FINAL MITIGATION PLAN

**Groundhog Hollow Project
Alexander County, North Carolina**

**DMS Project #: 100049
Contract #: 7417
USACE Action ID: SAW-2018-00450
RFP: 16-007277**

Re: NCIRT Review and USACE Approval of the NCDMS Groundhog Hollow Site / Alexander County / SAW-2018-00450; NCDMS Project # 100049

S10

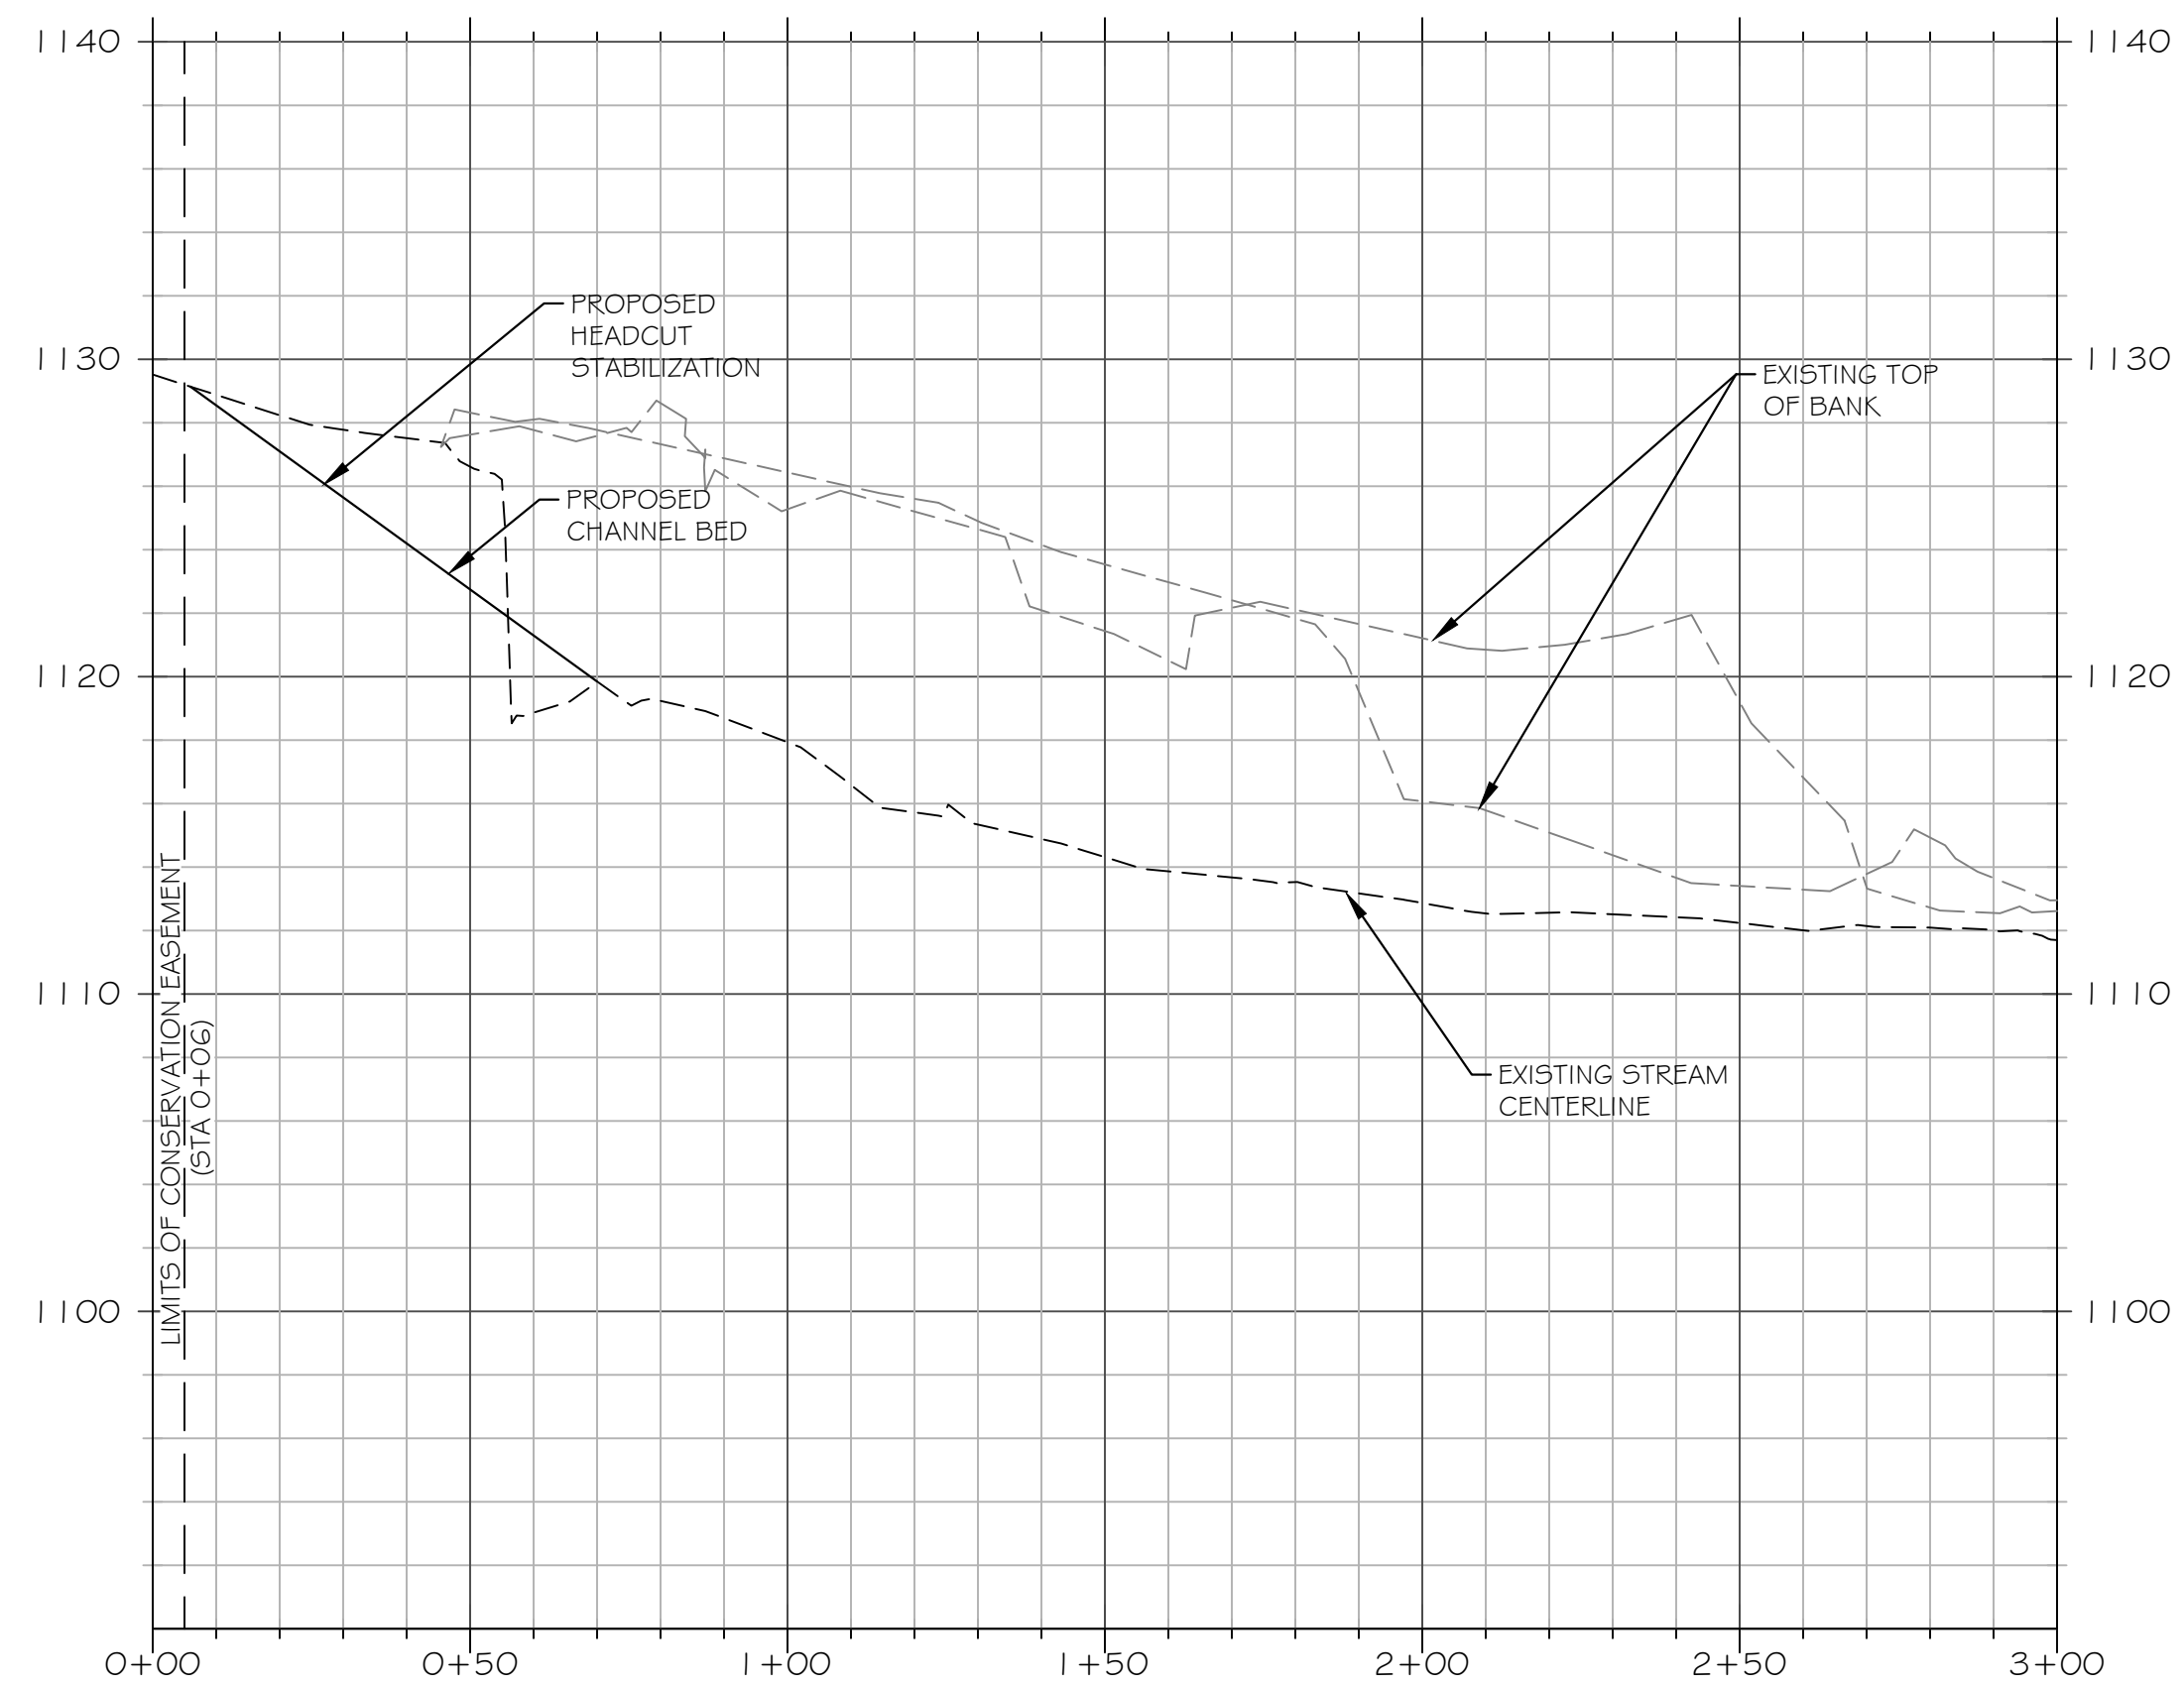
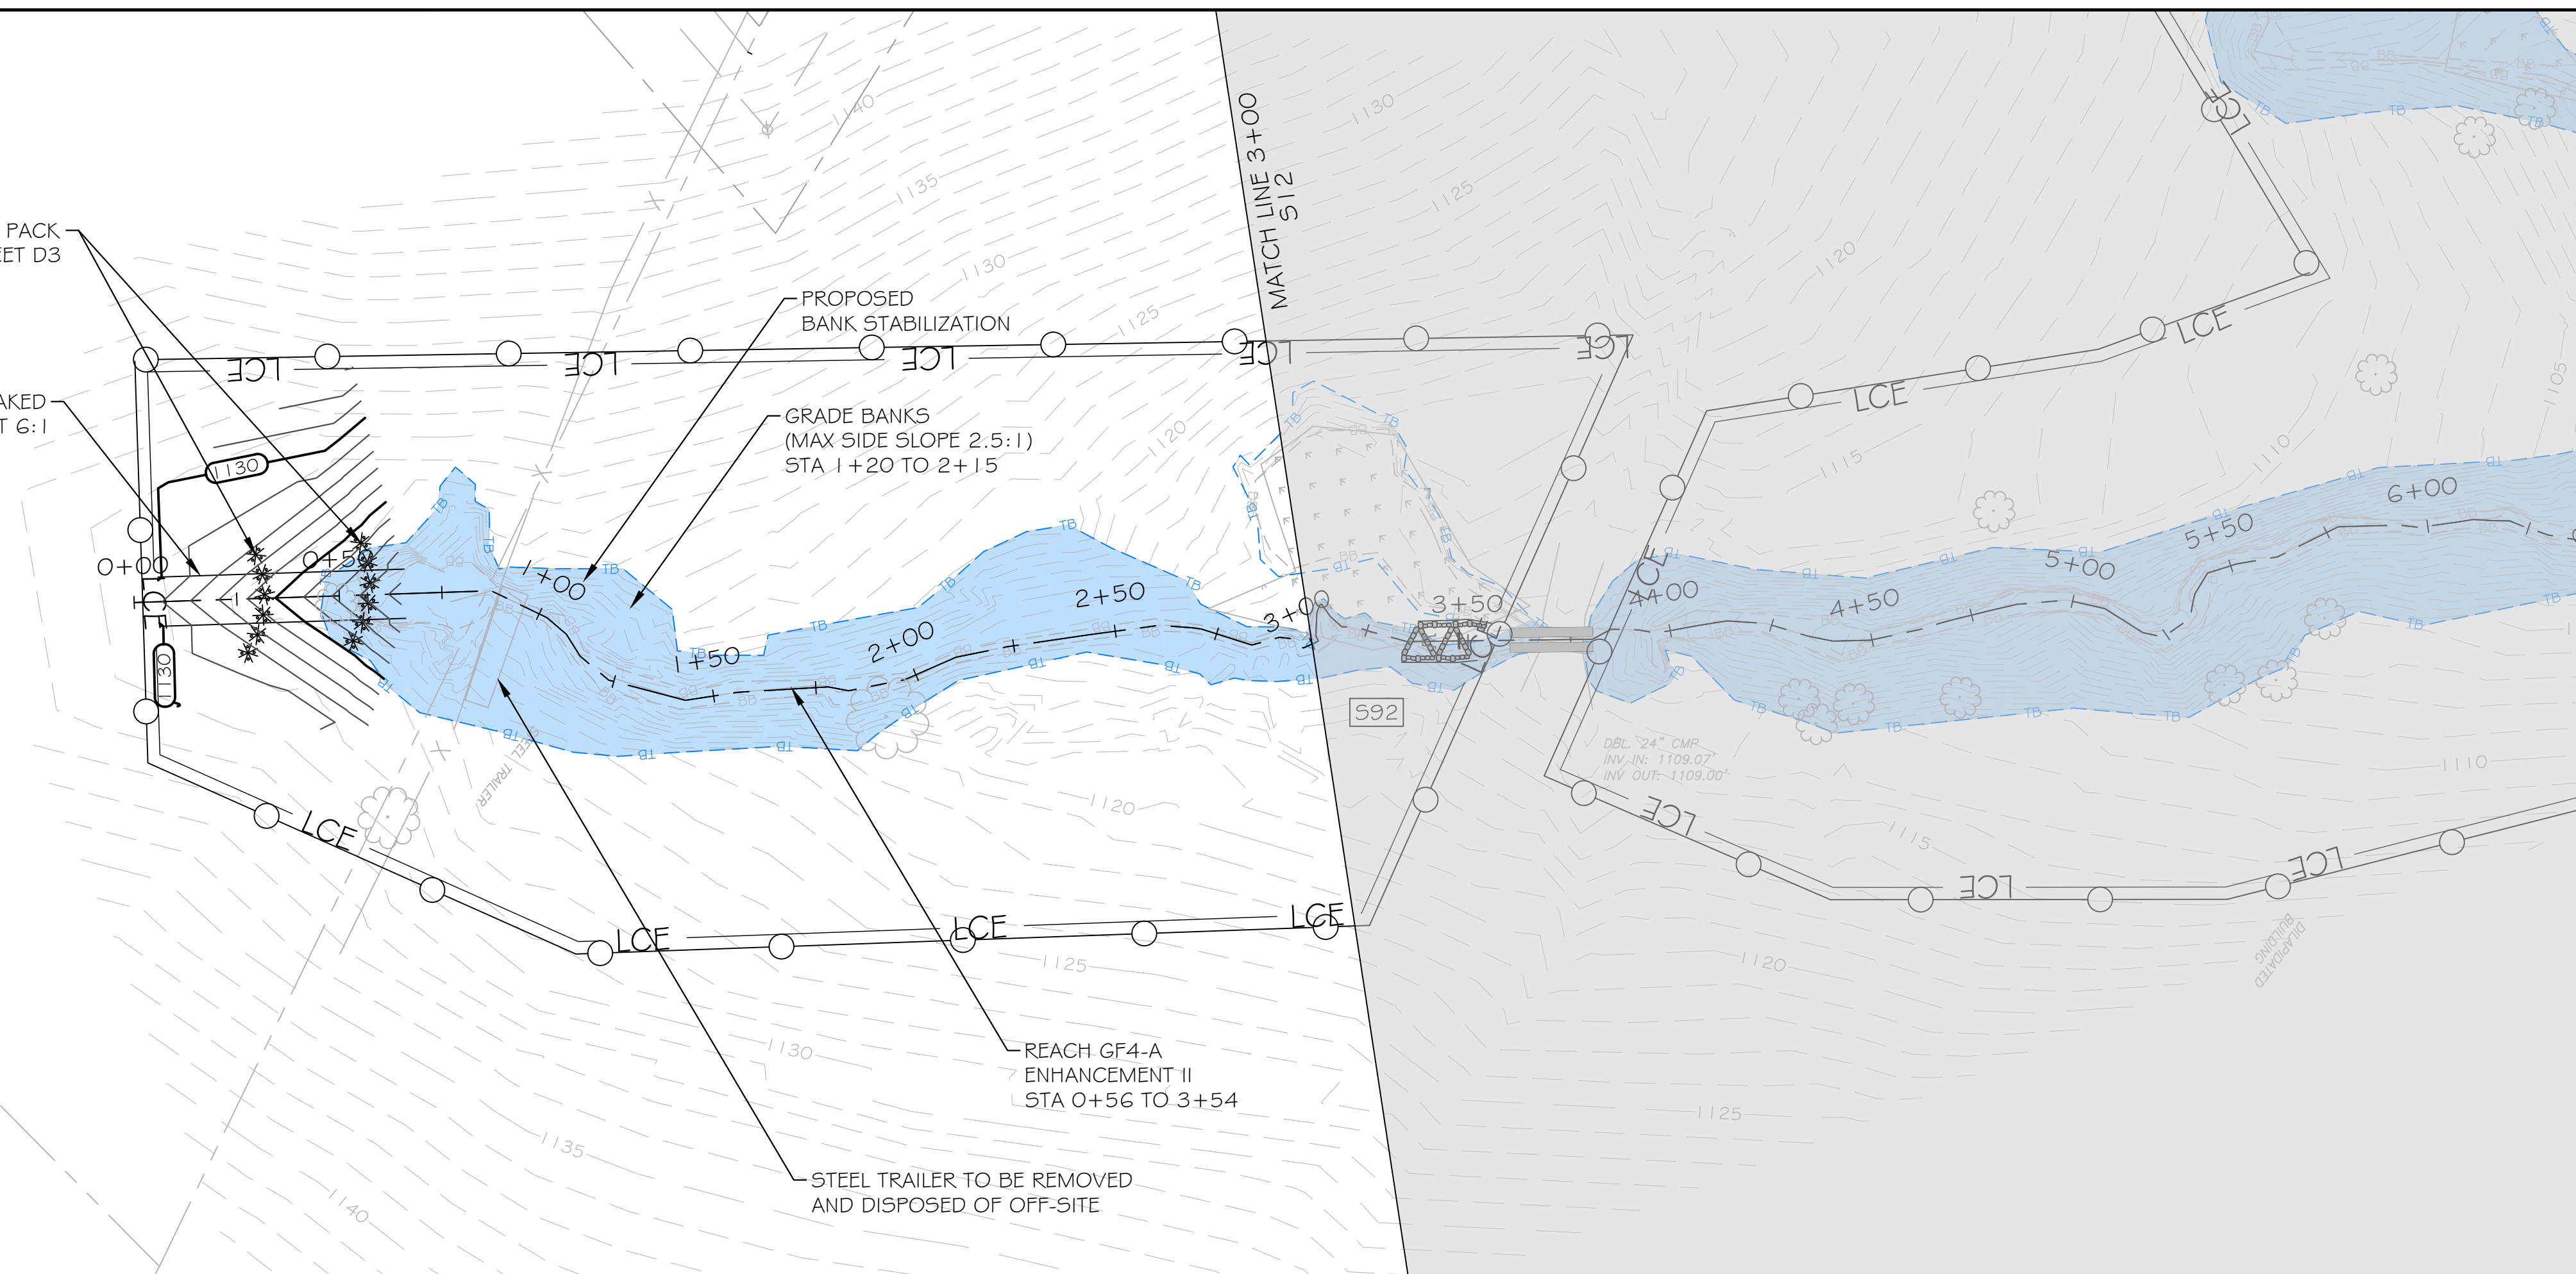
16. Sheet S6 – Did you consider installing a constructed riffle at the transition from Restoration to Enhancement II reaches on GF1-B (34+50)?
17. Sheet S6 & S10 – Please explain why proposed grading limits extend outside of the easement.

17. **Sheet S6 & S10** – Please explain why proposed grading limits extend outside of the easement.
Grading limits extend outside the easement because RES will be filling the existing channel located outside of the easement.

SOD MATS

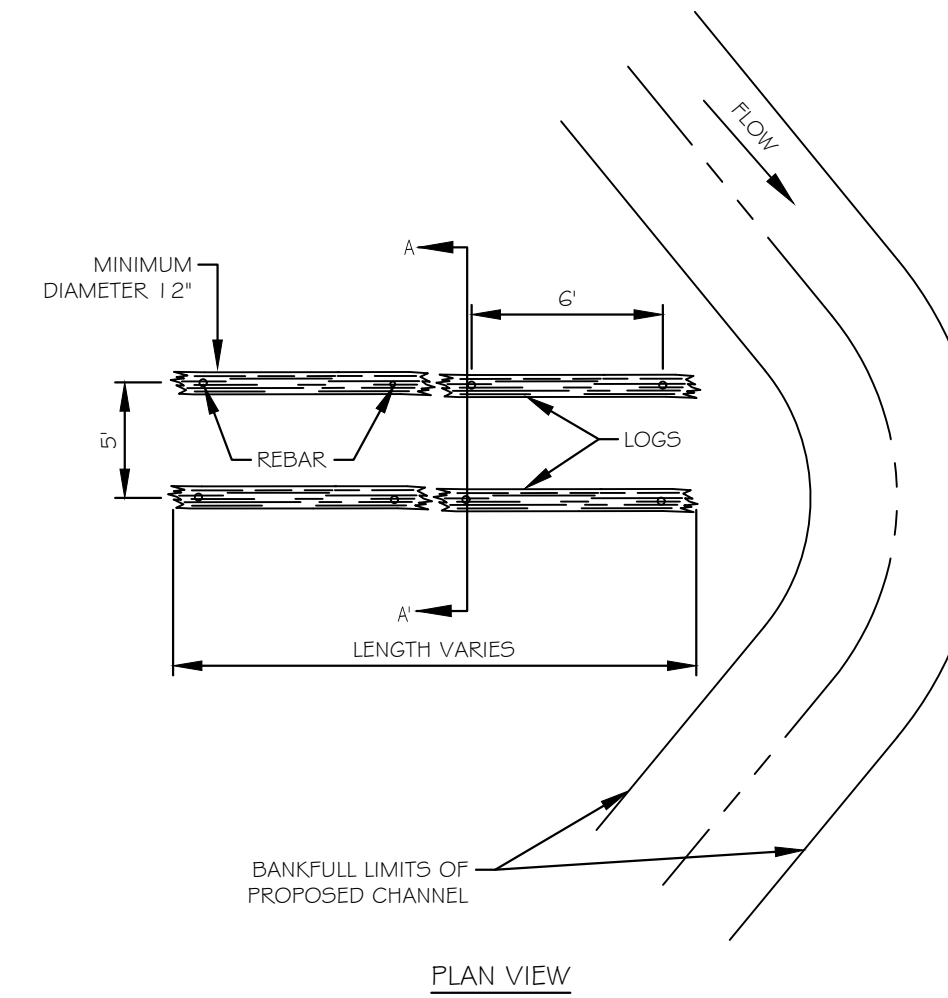
3. Section 6.2, page 24 In-Stream Structures – Sod mats are identified as a potential bank stabilization treatment. Please include a detail for this treatment in Appendix A or add treatment information to applicable existing detail(s).

3. **Section 6.2, page 24 In-Stream Structures** – Sod mats are identified as a potential bank stabilization treatment. Please include a detail for this treatment in Appendix A or add treatment information to applicable existing detail(s).
A detail has been added to sheet D4.
